Environmental Site Remediation Work Plan

NMOCD District:	Eddy	Incident ID:	nAPP2308926215
Landowner:	New Mexico State Trust Lands	Lat/Long:	32.07028,-103.95472
Client:	Solaris Water Midstream	Site Location:	Eddy State Water Recycling
Date:	May 16, 2025	Project #:	25A-01145
Client Contact:	Jeffery Cook	Phone #:	832.304.7003
Vertex PM:	Chance Dixon	Phone #:	575.689.7007

Action 464772

Operator: SOLARIS WATER MIDSTREAM, LLC 9651 Katy Fwy Houston, TX 77024	OGRID: 371643
	Action Number: 464772
	Action Type: [C-141] Site Char./Remediation Plan C-141 (C-141-v-Plan)

Proposed Final Remediation Area
Eddy State Water Treatment and Reuse Facility
Eddy State #002

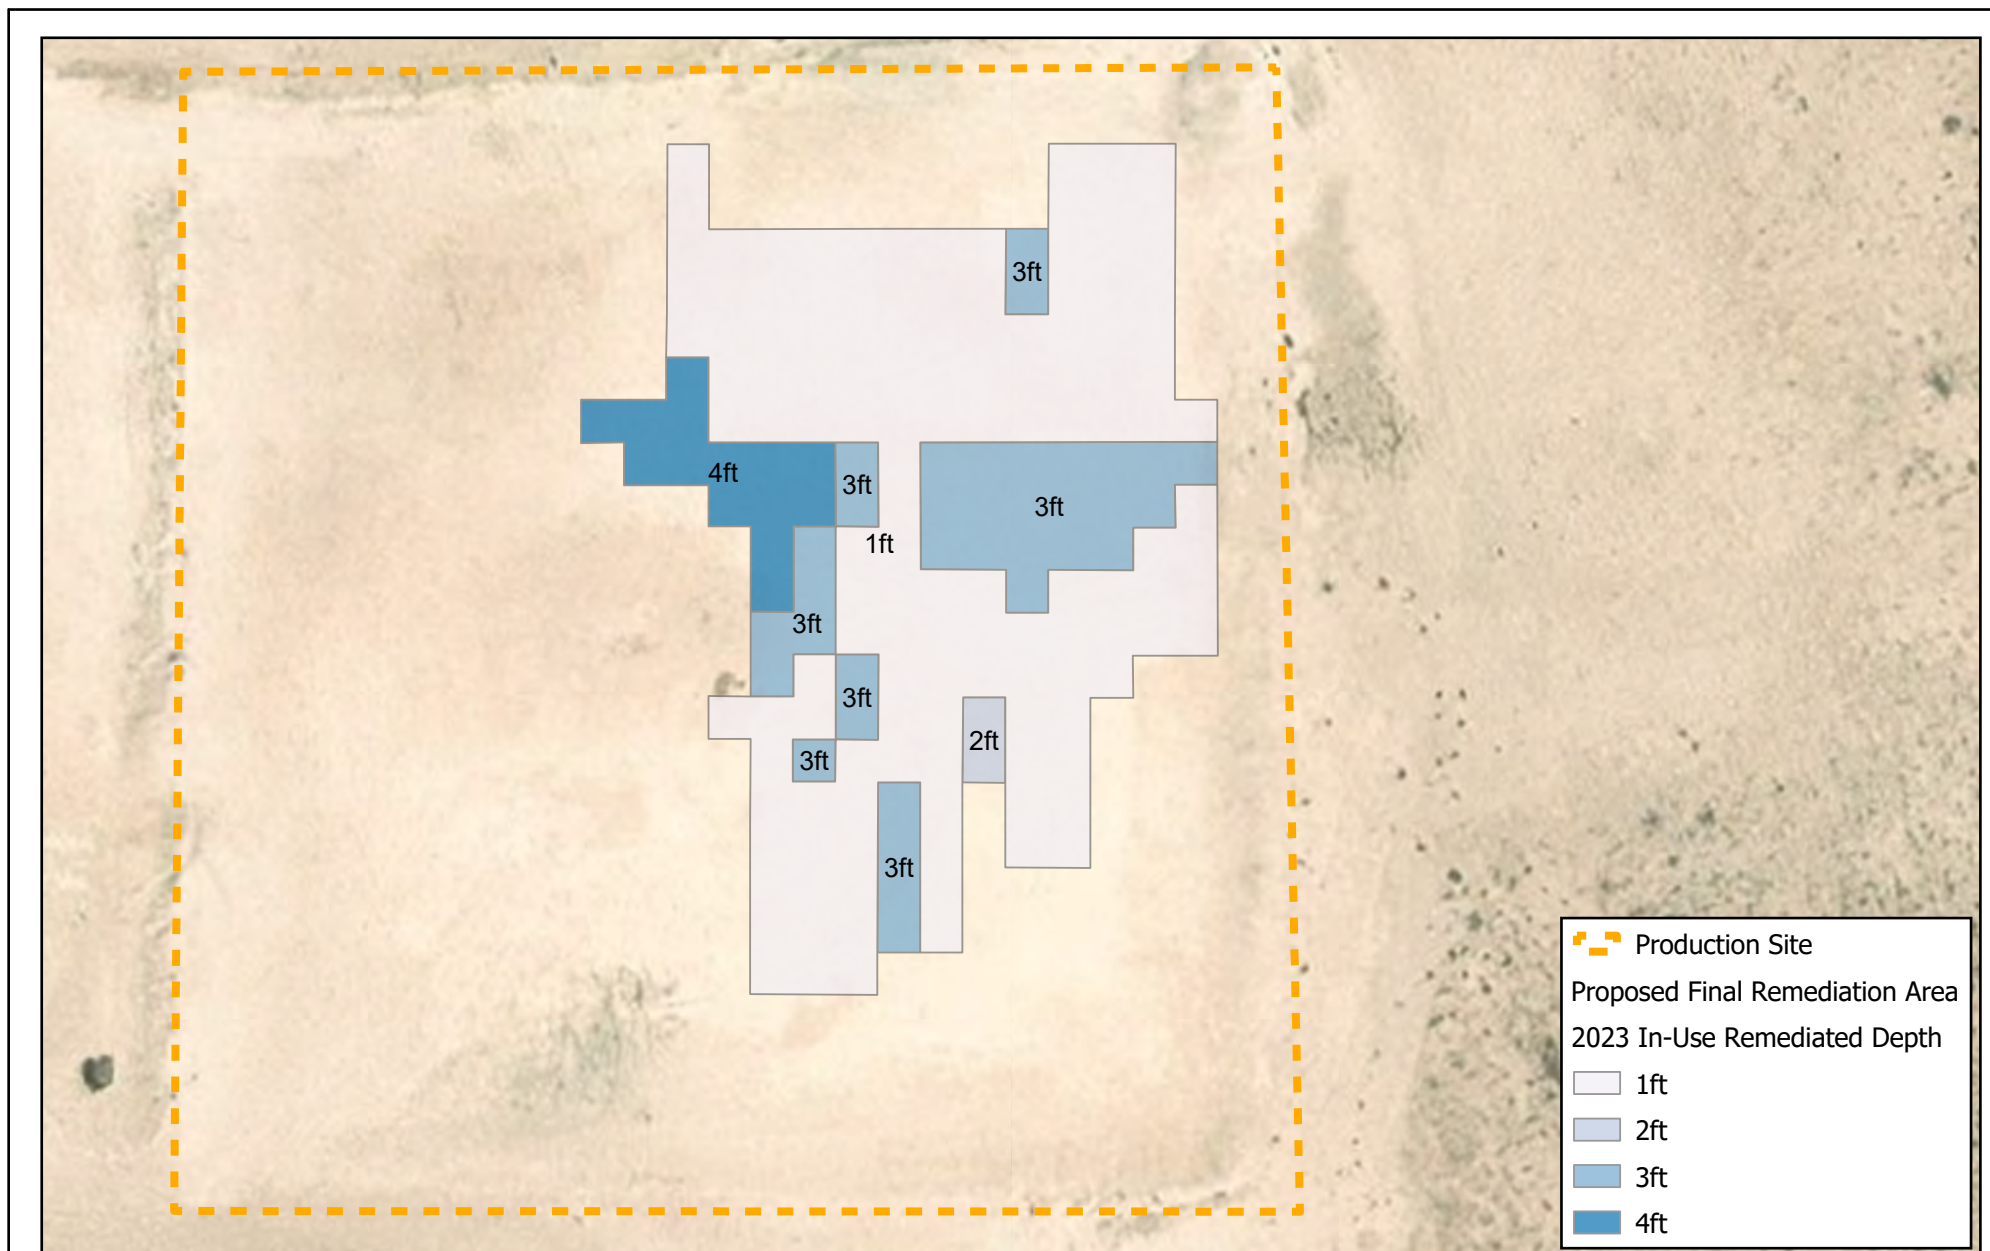
Created By	Condition	Condition Date
rhamlet	The Remediation Plan is Conditionally Approved. Delineation results, including laboratory analysis, need to be included on future remediation plans. All delineation sample points should be included on the delineation site map. The Variance Request for 400 ft2 floor confirmation sample size is approved. The release area will still need confirmation sidewall samples representing no more than 200 ft2. Collect 5-point confirmation floor samples every 400 ft2 throughout the "entire release area" and not just at delineation sample point locations that show contaminants over closure criteria standards. Make sure these are all included on the final confirmation sample site map. Back-fill material for reclamation and stockpiled soils must meet OCD strictest standards of 600 mg/kg for chlorides.	6/18/2025
rhamlet	All samples must be analyzed for all constituents listed in Table I of 19.15.29.12 NMAC. Floor confirmation samples should be delineated/excavated to meet closure criteria standards from Table 1 of the OCD Spill Rule for site assessment/characterization/proven depth to water determination. Sidewall samples should be delineated/excavated to 600 mg/kg for chlorides and 100 mg/kg for TPH to define the edge of the release. All off-pad areas must meet reclamation standards in the OCD Spill Rule. The work will need to be completed in 90 days after the report has been reviewed.	6/18/2025
